June 11, 2025

LANCASTER COUNTY COUNCIL**COMMITTEE OF THE WHOLE**

MINUTES

Figure 4.3.1.2-1: Hold for Updated Graphic Showing Landscaping and Screening Areas.

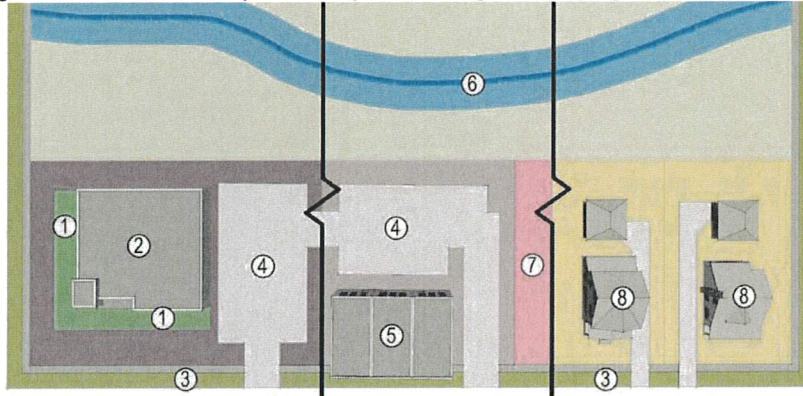
1. Perimeter Buffer – Note numbers do not match the current illustration.
2. Building Landscaping
3. Parking Lot Landscaping
4. Street Trees & Streetscaping
5. Major Subdivision Entry Landscaping
6. Riparian Buffers
7. Open Space

Figure 4.3.4.2-1: Hold for Updated Graphic Showing Parking Lot Landscaping.

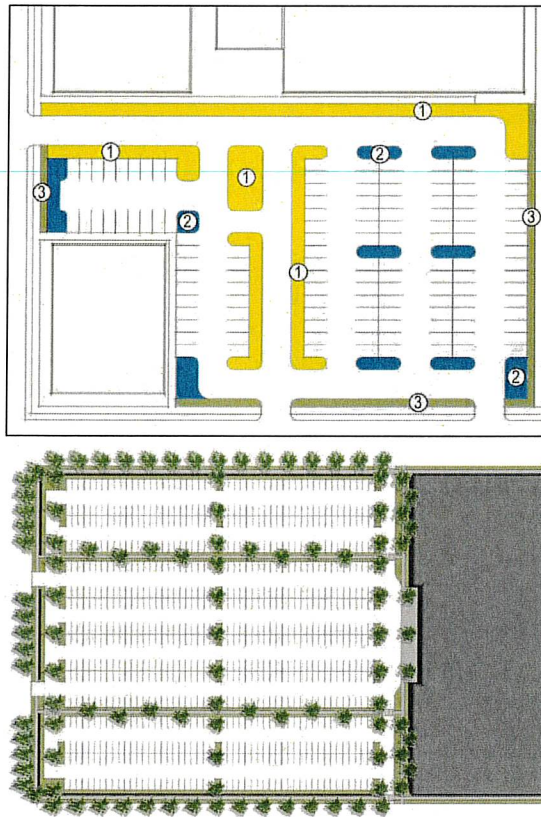
increases the screening and planting requirements for parking lots and also implements parallel standards for the RUB, HCO, and all other districts to allow for rural and suburban place types.

Figure 6.5-2: Examples of Fully-Shielded Luminaires

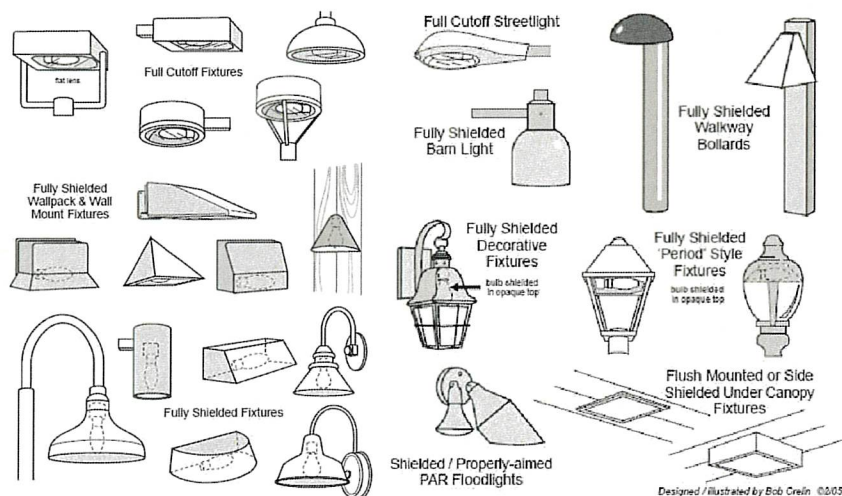
9. Figure 6.5.-2 was described as a good example of a helpful graphic for interpretation.
10. *6.6 – General Standards for All Outdoor Lighting:* the maximum height limits under 6.6.2 should be adjusted to accommodate increased height in the HCO district, if the current text amendment that the Planning Commission reviewed is approved by Council.

use this image in the UDO; as such it could be removed or replaced in the next draft of this Chapter. It is included here to help explain the concept of BUG ratings.
